Re: 4004 – Trevi Village – Multi-Family Rezoning (2017-088)

The following is a list of responses to the City staff rezoning comments received on June 13, 2017:

### **Staff Review Comments – Preliminary Plat:**

**RZ-100**

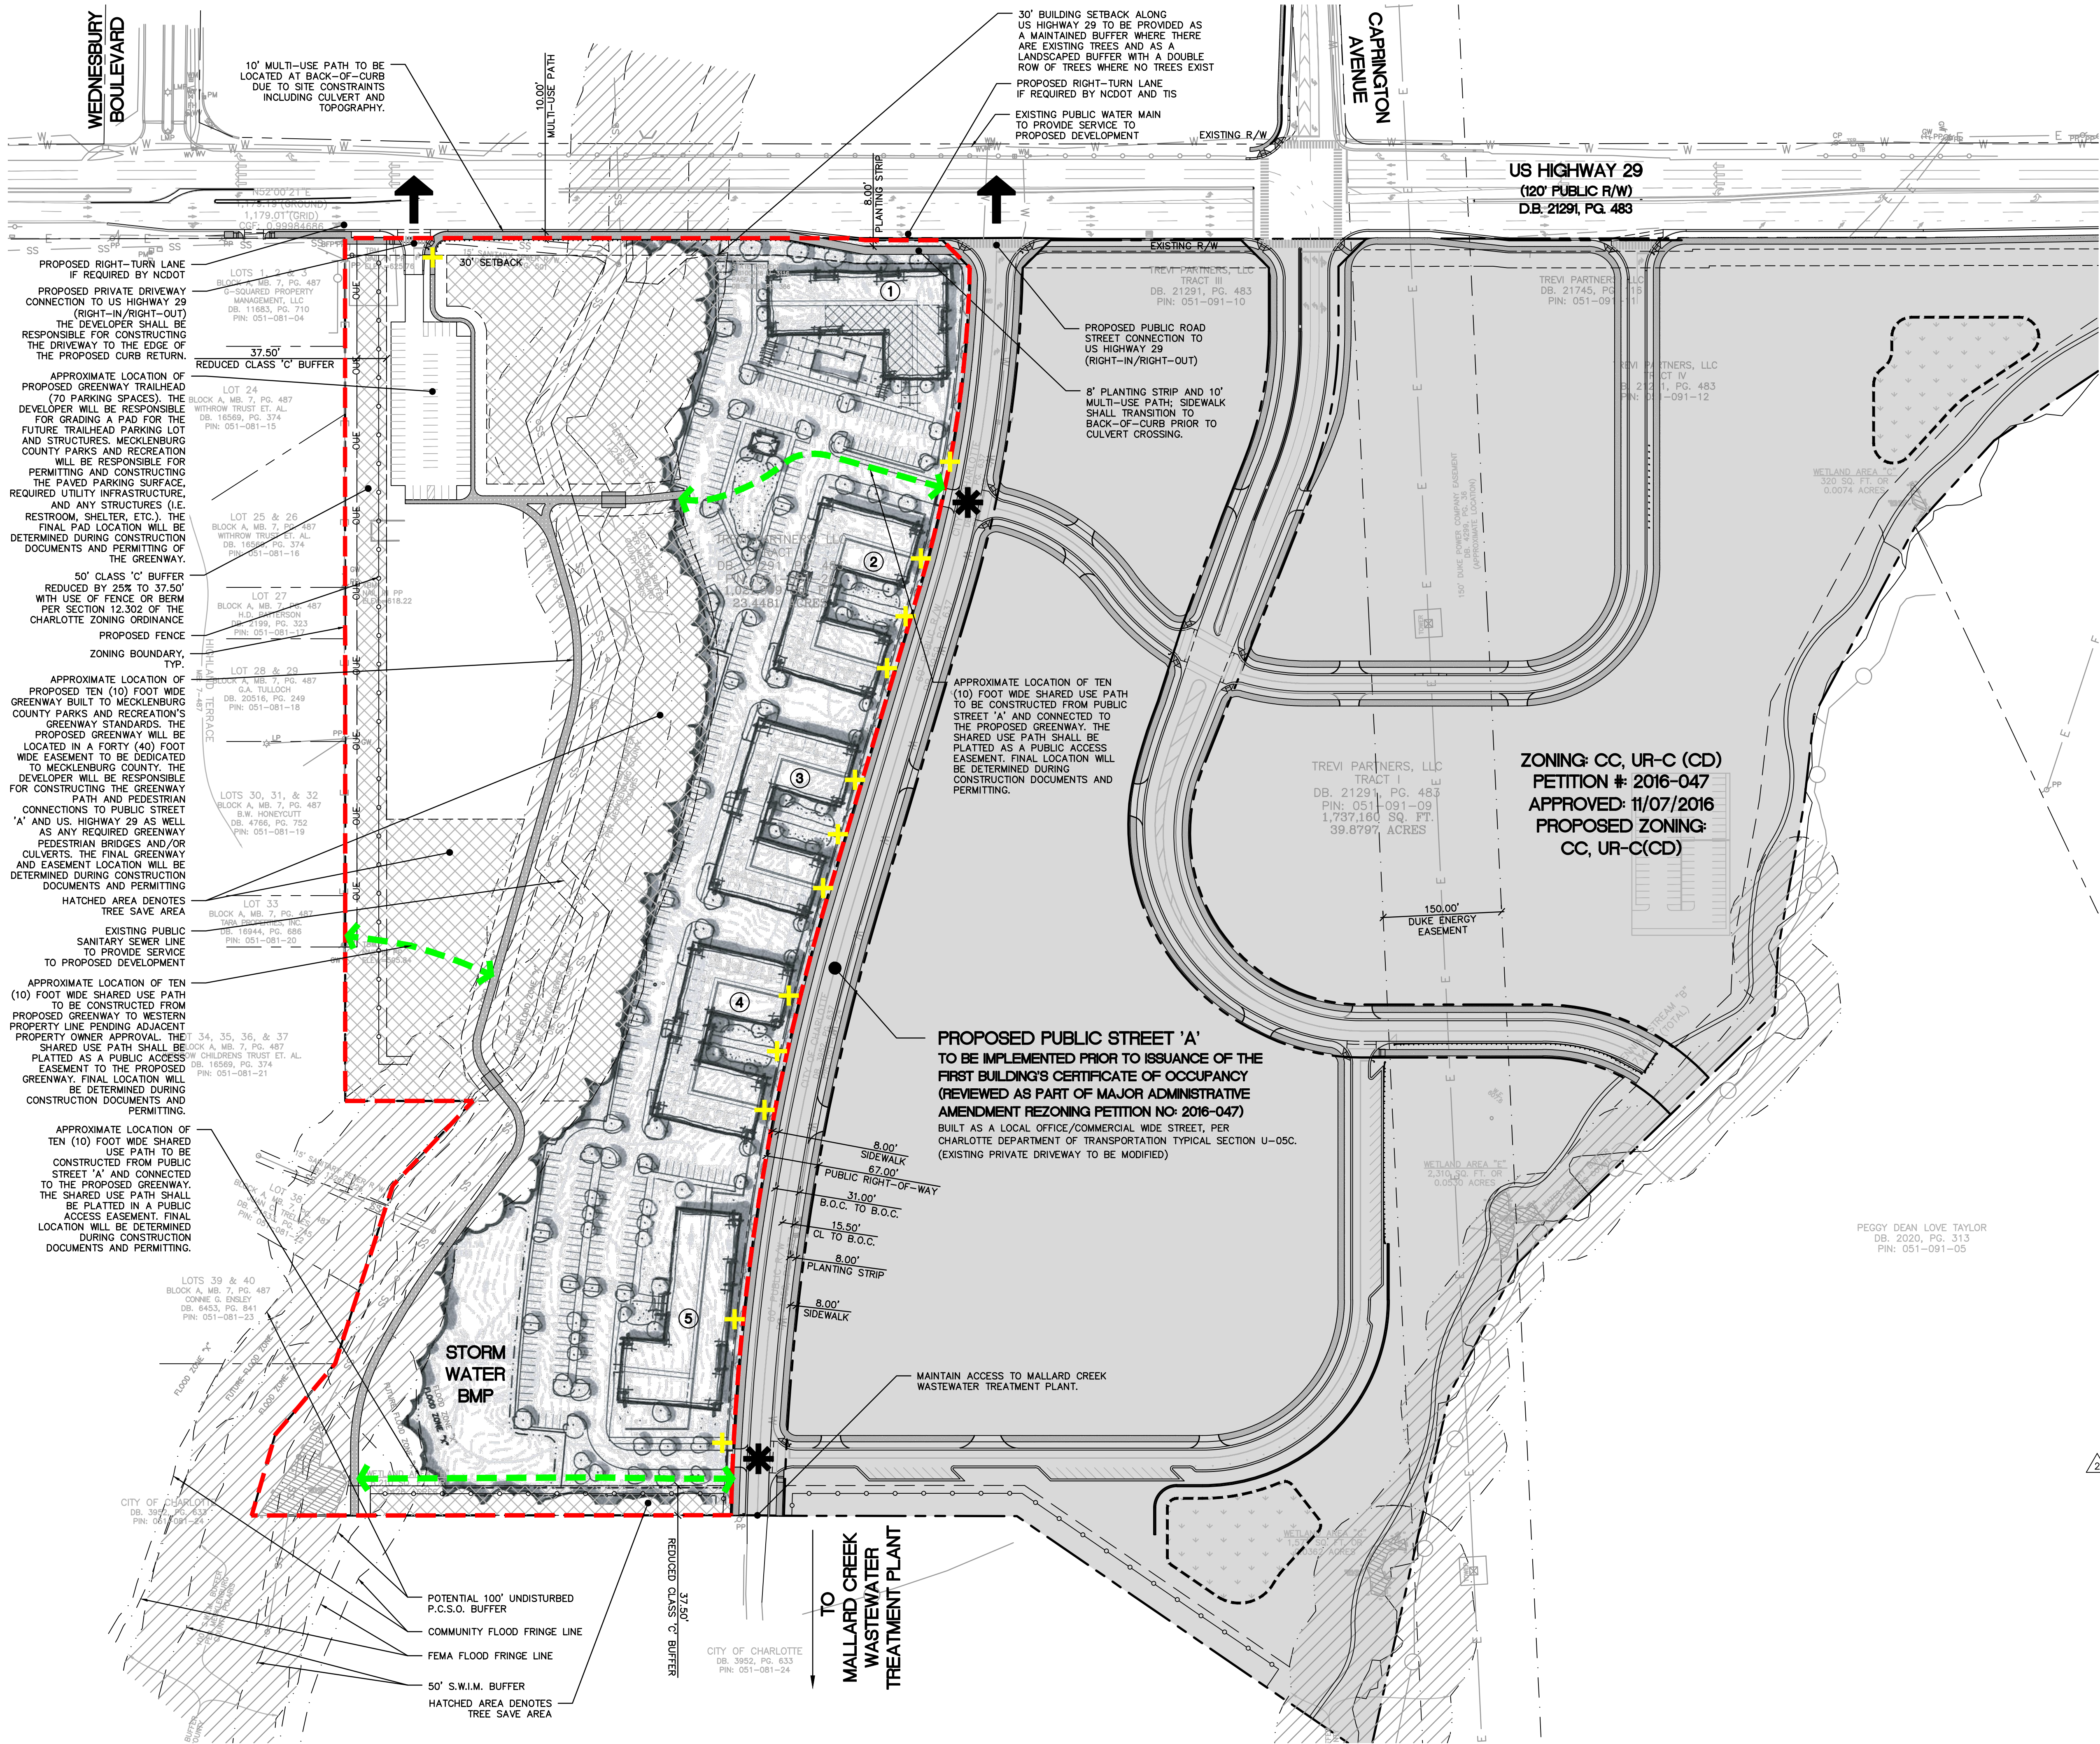
2. Check and confirm potential water quality buffer widths and locations. 200-foot Post Construction Stormwater buffers are not located in this watershed.

5. Provide the maximum building height in feet in addition to the number of stories already indicated.

**Comment noted. All references to the post-construction stormwater buffers are noted as 100-ft. Please refer to sheet RZ-100.**

**The maximum building height has been updated in the rezoning summary and development standards to reflect a maximum height of 60' in addition to the 4-story requirement. Please refer to sheets RZ-100 & RZ-200.**

RZ-200

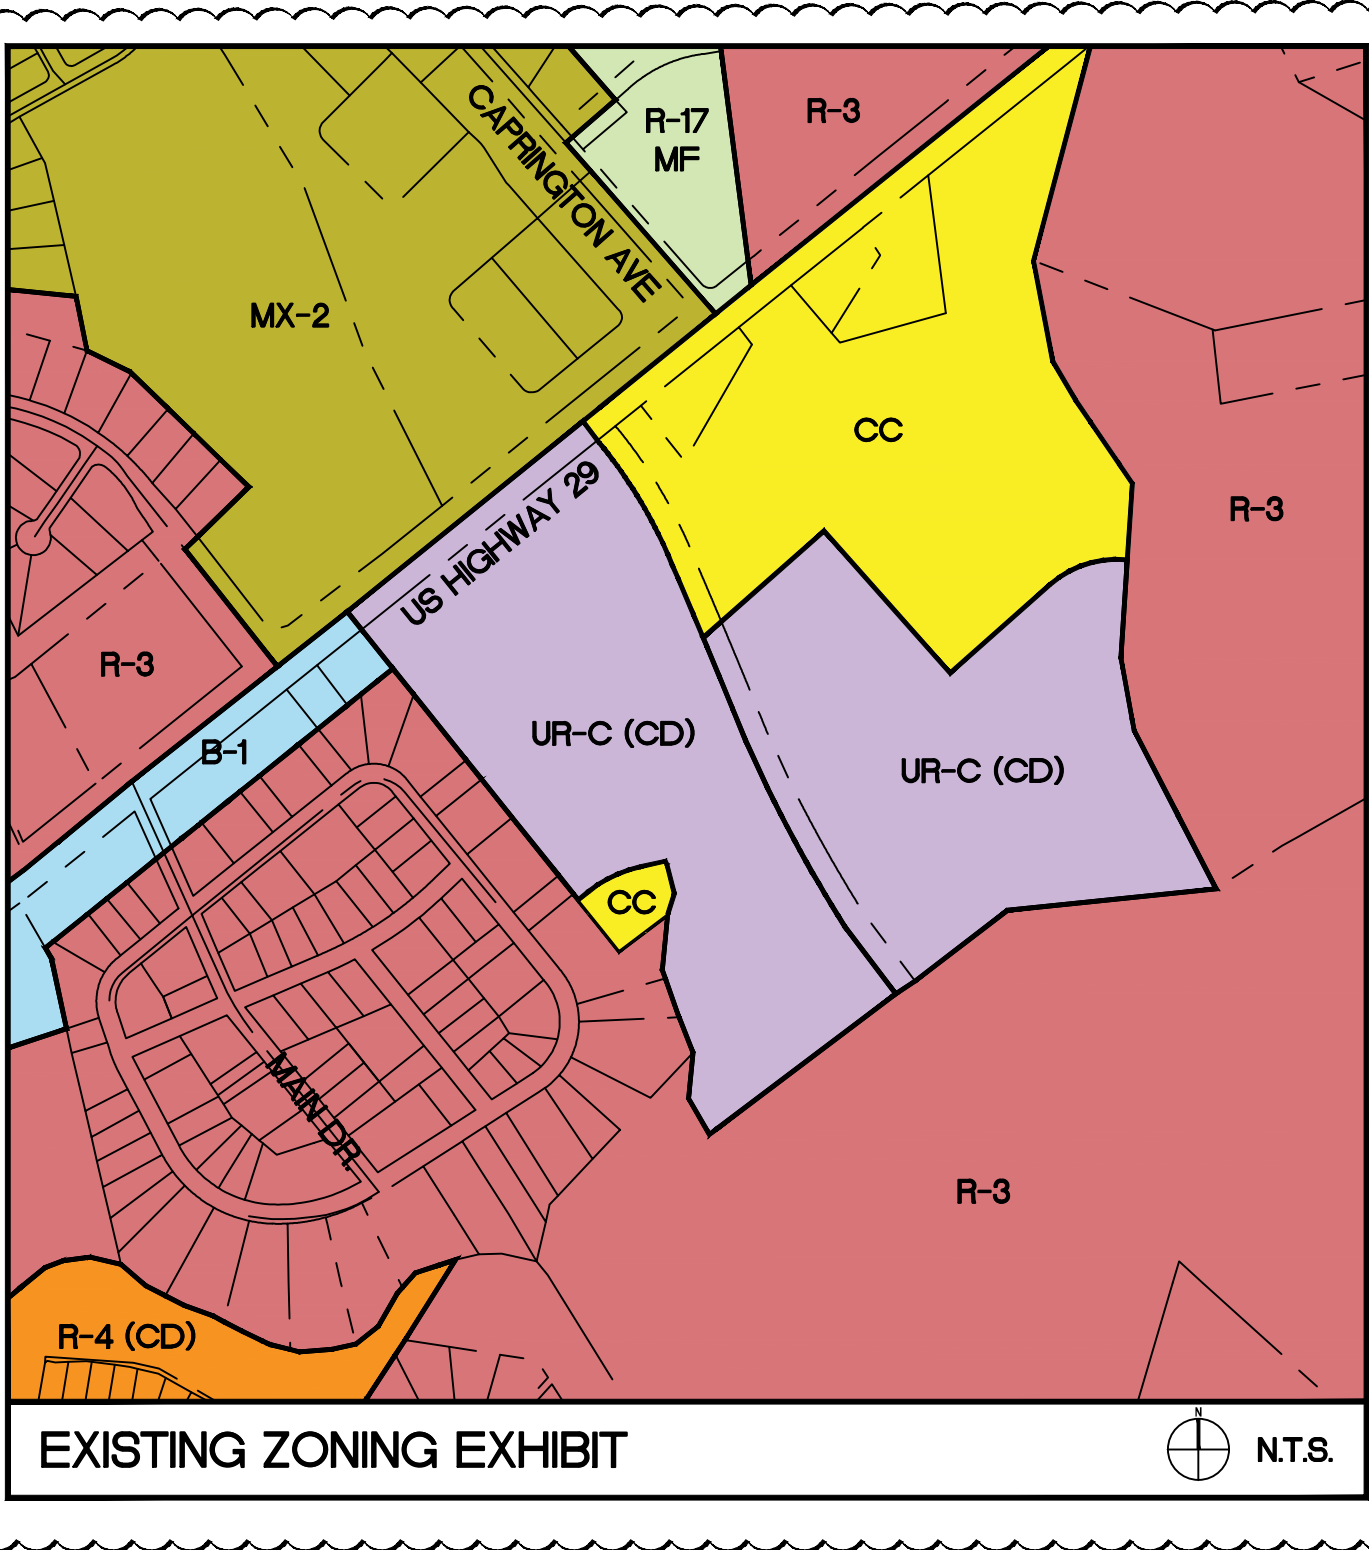
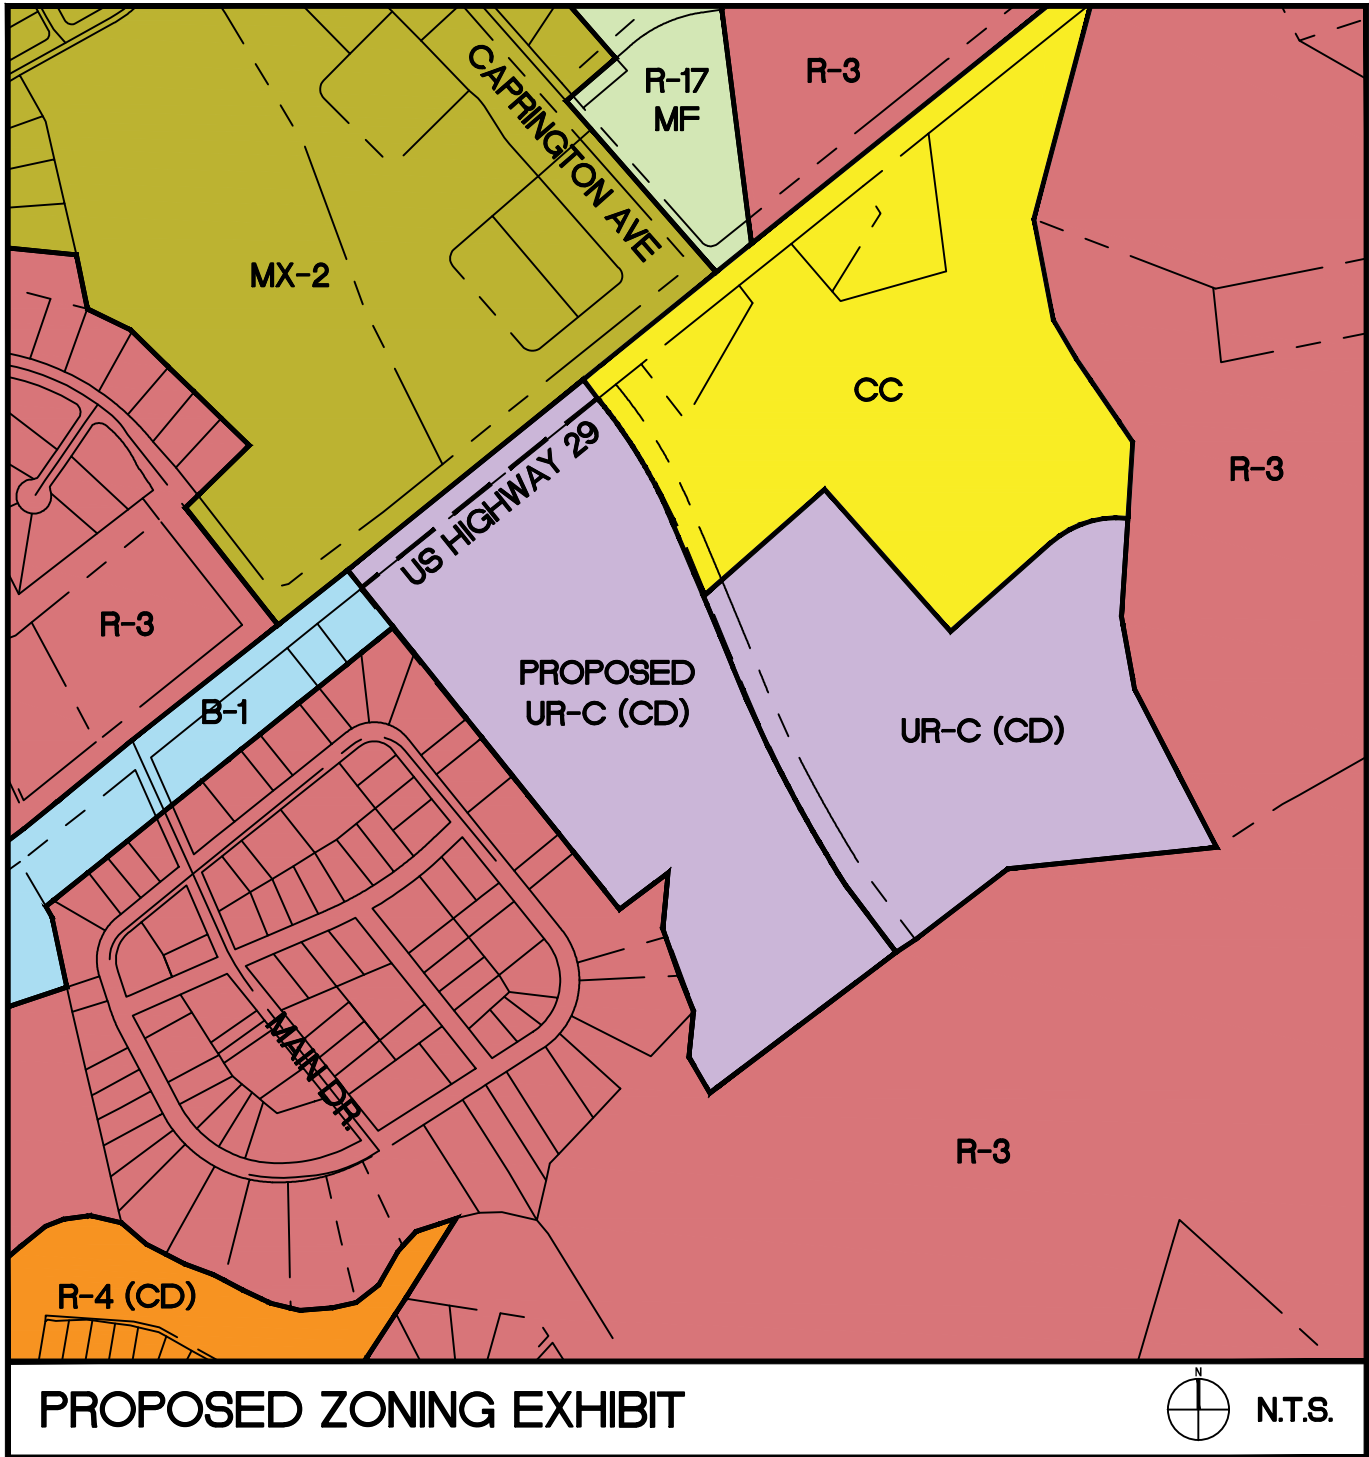
1. Add the following note under the ENVIRONMENTAL FEATURES heading:  
“Development or disturbance within the PCSO or SWIM Stream Buffer shall be coordinated with Charlotte-Mecklenburg Storm Water Services and mitigated if required by City ordinance.”

3. Delete existing Note 1(d) in its entirety, and replace with the following: Future amendments to the rezoning plan may be applied for in accordance with Chapter 6 of the zoning ordinance. Alterations to the zoning plan are subject to Section 6.207 of the ordinance.

4. Amend Note 1(b) by deleting the following: Subject to the optional provisions set out below, the regulations established under the ordinance for the UR-C(CD) zoning district classification shall govern development taking place on the site.

6. Amend Note 4(c)(i) and (iii) to replace “network required streets (public or private) with “public street on the site,”.

7. Clearly delineate and label the two existing zoning districts on the site plan.

**The required note has been included in the Development Standards under the Environmental Features section. Please refer to sheet RZ-200.**

**Note 1(d) has been removed and replaced as noted in the staff analysis. Please refer to sheet RZ-200.**

**Note 1(b) has been amended as noted in the staff analysis. Please refer to sheet RZ-200.**

**Notes 4(c)(i) and 4(c)(iii) have been amended as noted in the staff analysis. Please refer to sheet RZ-200.**

**An existing zoning exhibit inset has been added to the development standards sheet. Please refer to sheet RZ-200.**
